Luensmann Offsite Water Main Ext PH1
Solicitation Number: CO-00717
Job No.: 23-1043

ADDENDUM 1
11/16/2023

PLAT NO. 12473-09
 JOB NO. 12473-09
 DATE MARCH 2023
 DESIGNER CD
 CHECKED MP DRAWN CD
 SHEET C3.00

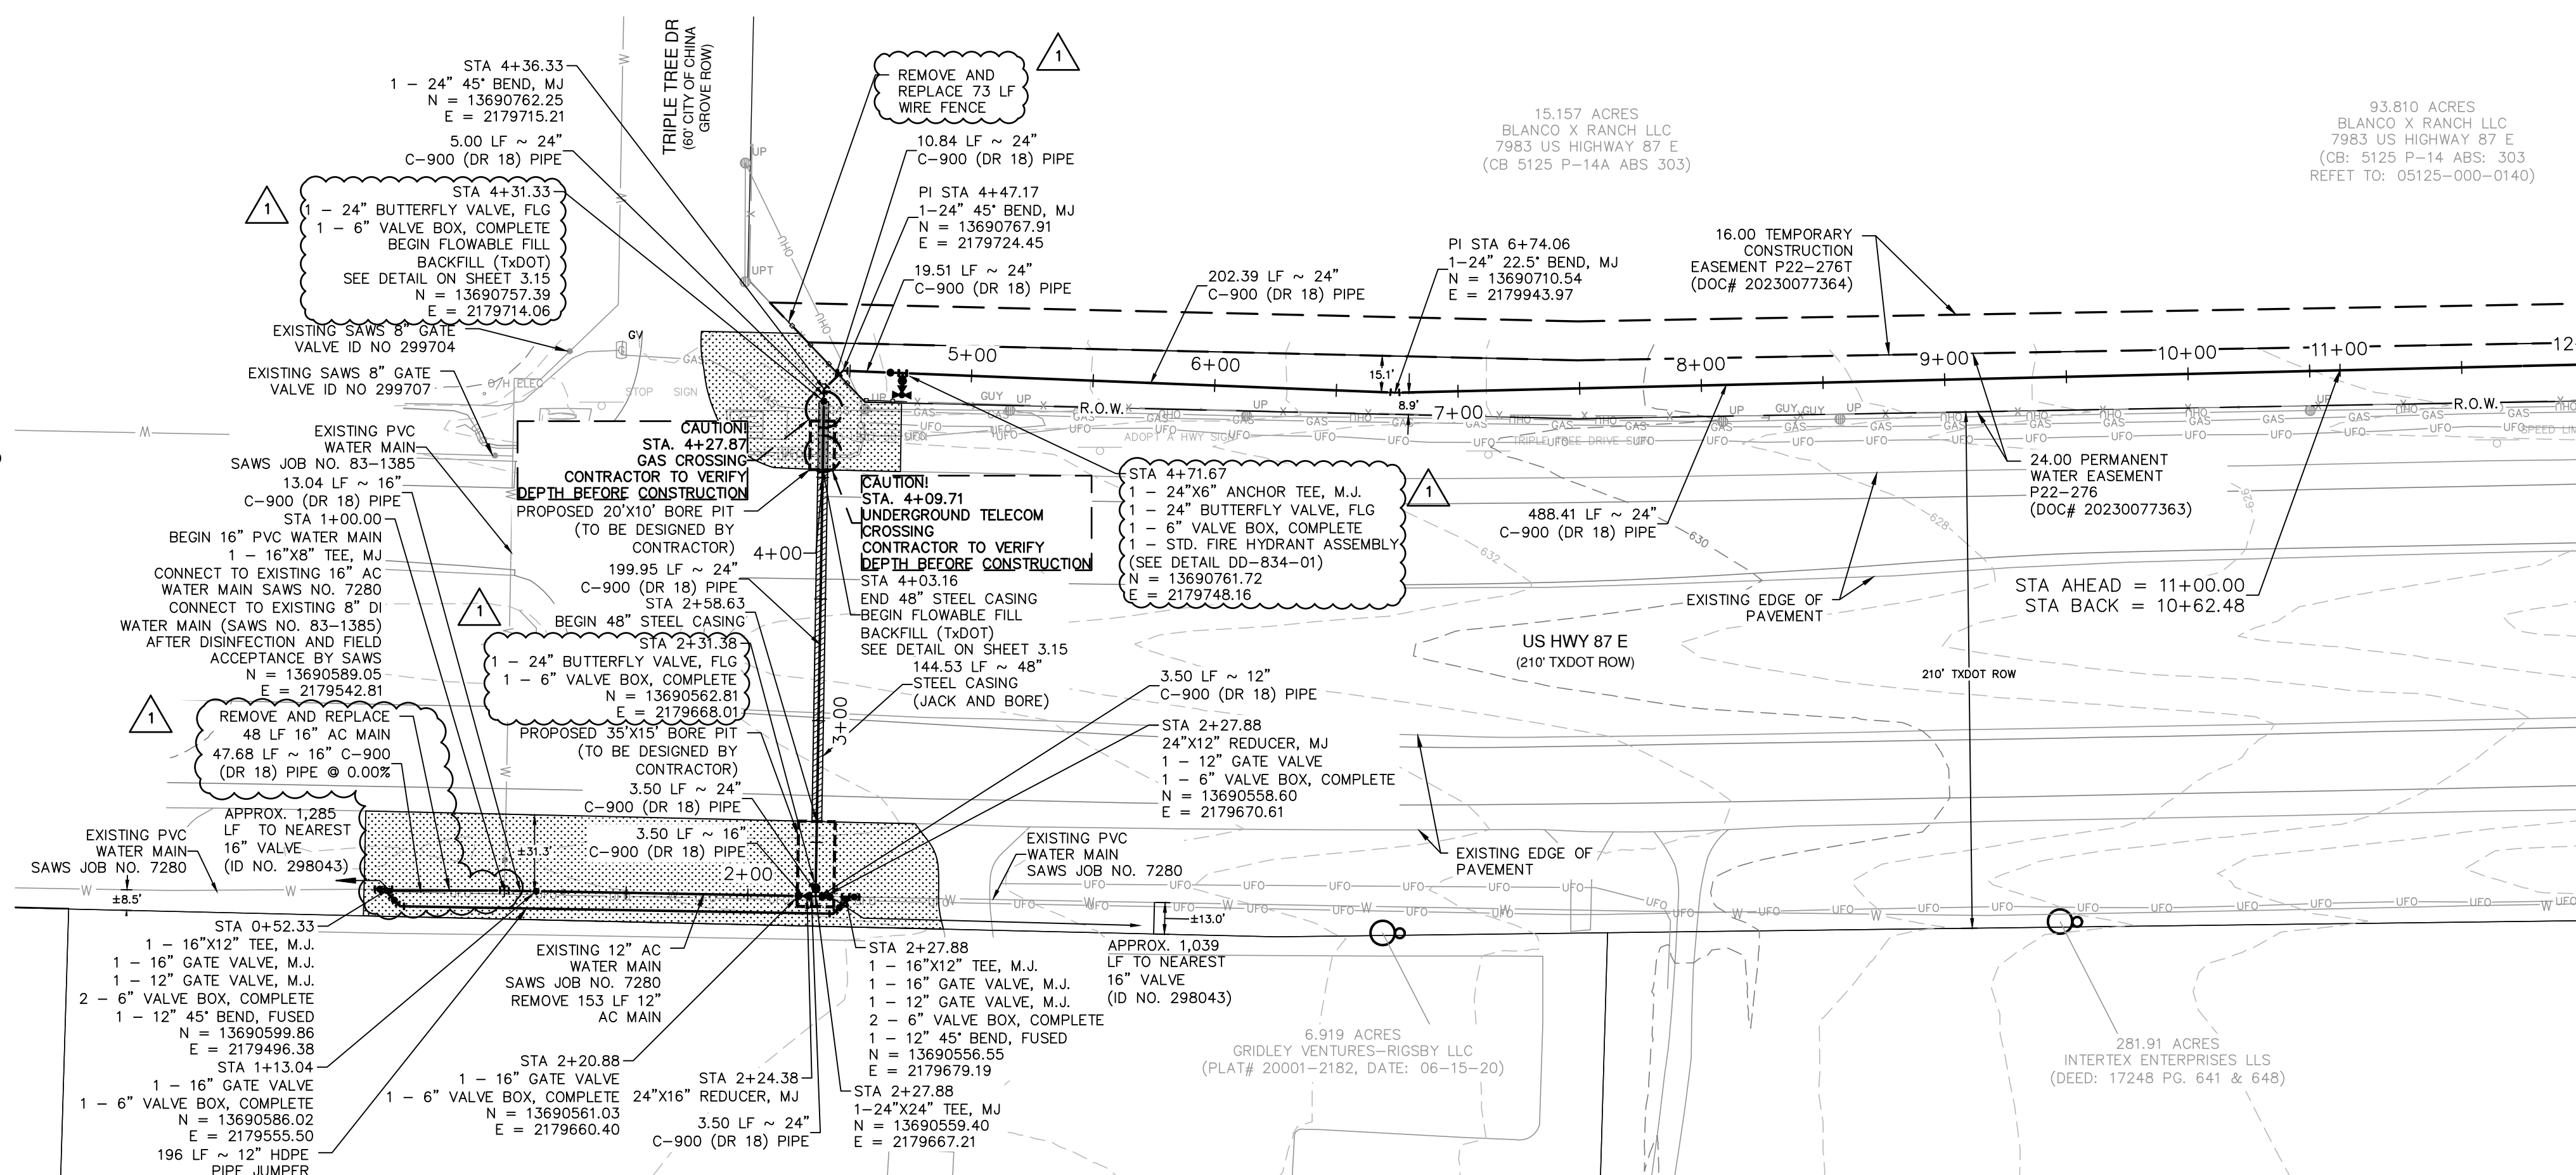
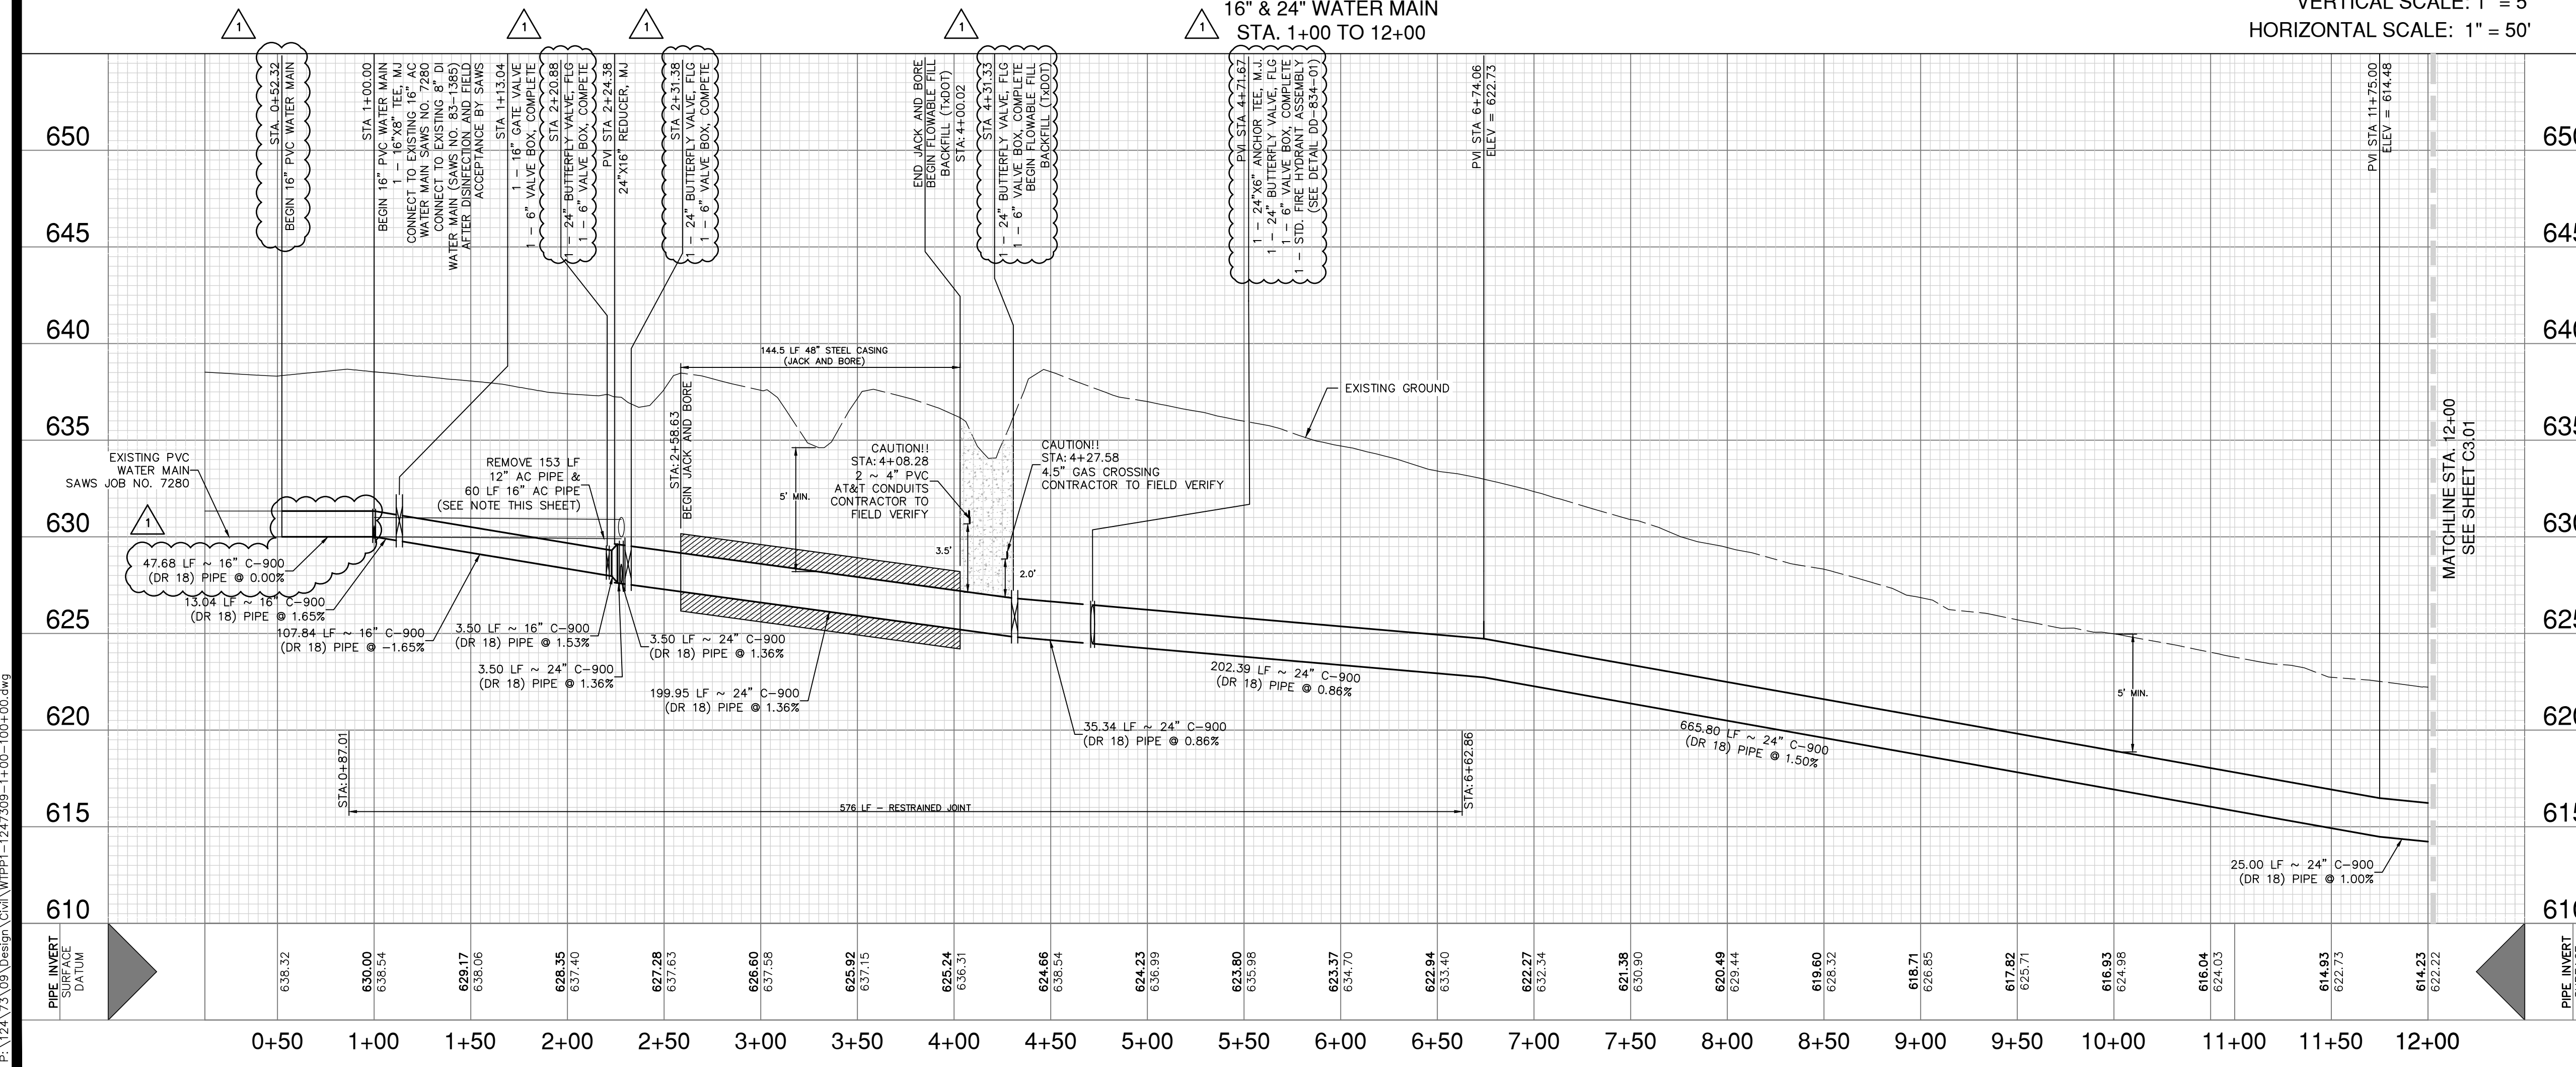
- Question:** On plan sheet 3.00. Remove 60 LF 16" AC main. 1+00 begin 16" PVC water main. What is this going to tie into? +/- Station 1+75 remove 153 LF AC main. It's confusing what exactly is going on between Station 0+52.33 and station 2+27.88?

25. **Question:** On sheet C3.00 the call out says to connect to the existing 16" AC main at the tee, but then it also says to remove 60 LF of the AC main. If the existing main is removed then the jumper would need to remain in place permanently since there is nothing stating to replace that 60 LF with new PVC main.

26. **Question:** Where is the fence repair at Station 4+47 being paid for as it is not called out on the plans?

- Revised note to remove and replace AC water main.
 - Revised 24" Butterfly valve to be Flanged.
 - Updated quantity table for additional LF of 16" PVC C900 and add Remove and replace fence.

Response: See Changes to the Plans #2. Sheet C3.00 has been revised to clarify the work within this area. The main at 1+00 ties into the existing main crossing US 87 (SAWS job no. 83-1385). The revised sheet shows new main being placed between 0+52.33 and 2+27.88. See Changes to the Specifications #1. The quantity for "16" PVC C-900 (DR 18) Pipe (Open Cut)" has been updated accordingly.

Response: See response to question #1. The revised sheet now includes permanent water main installation for the 60 LF length mentioned above.

Response: See Changes to the Plans #2. Sheet C3.00 has been revised to show the removal and replacement of 73 LF of wire fence. See Changes to the Specifications #1. The quantities for "Fence Gate 16' Type 1" and "Remove and Replace Existing Fence" have been updated accordingly.

PLAT NO.	
JOB NO.	12473-09
DATE	MARCH 2023
DESIGNER	CD
CHECKED	MP DRAWN CD
SHEET	C3.01

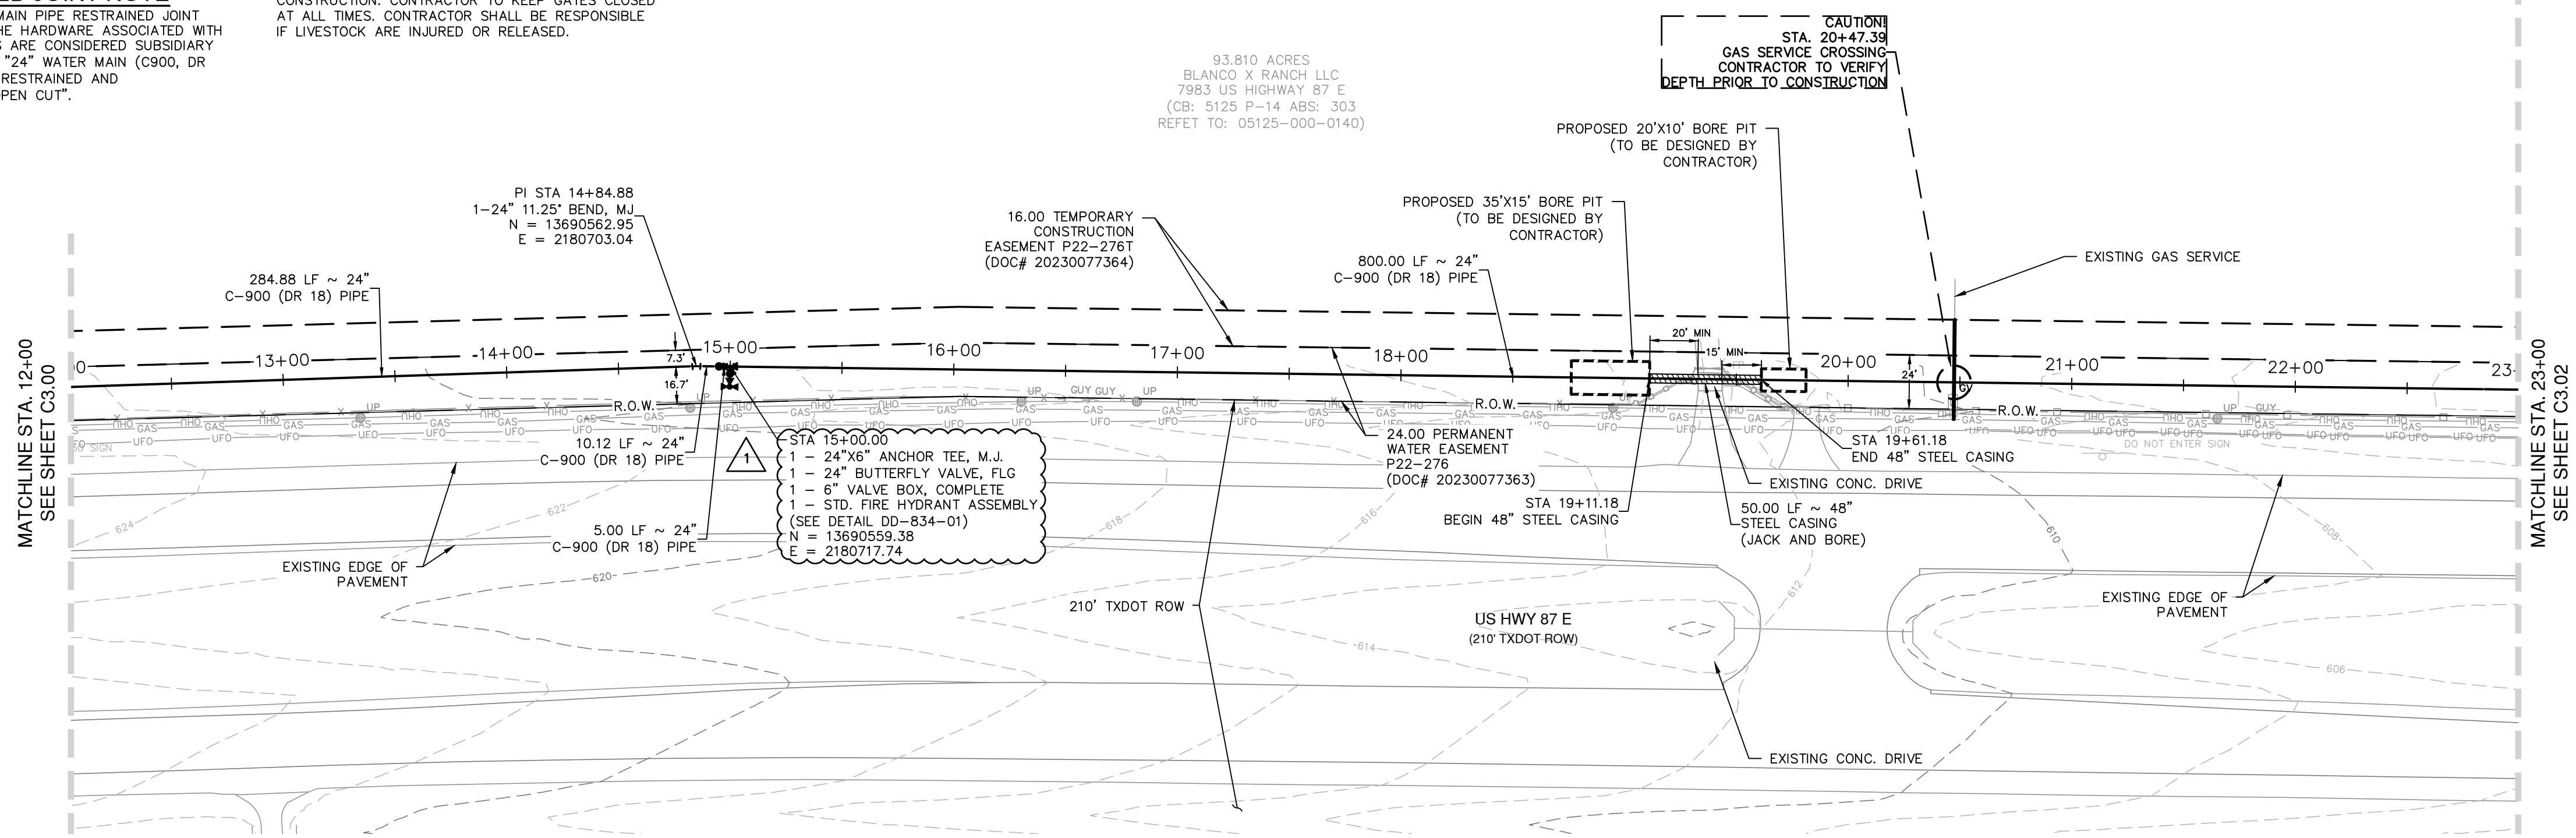
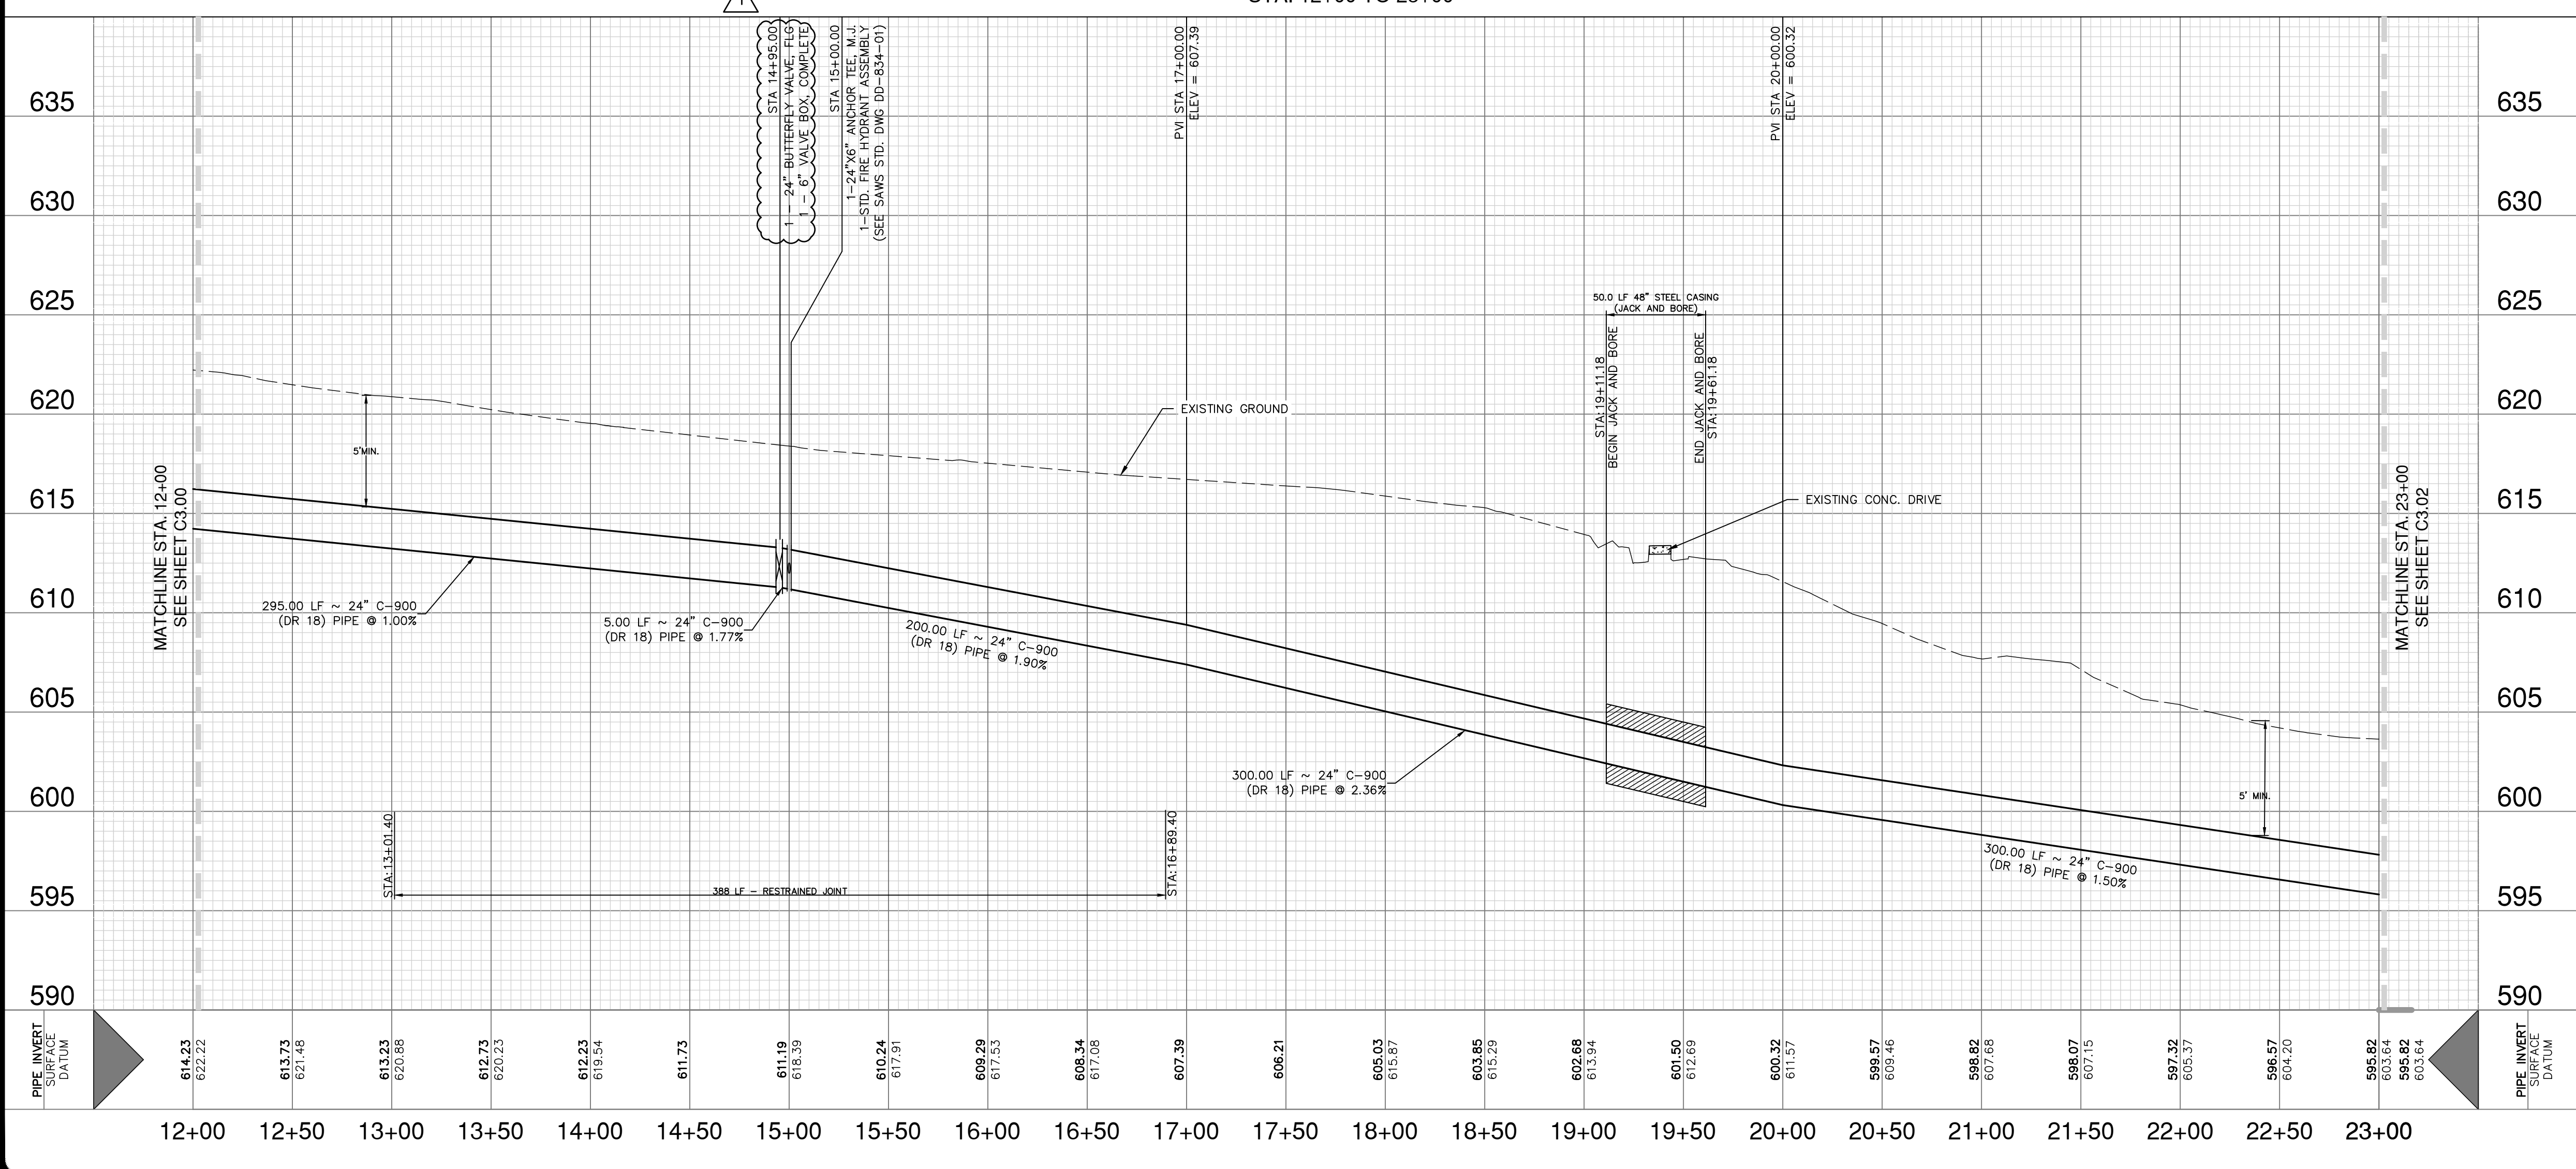
3. Sheet C3.01: Water Main Plan and Profile Sta 12+00 to 23+00 – Remove in its entirety and replace with the attached document.
 - Revised 24" Butterfly valve to be Flanged.
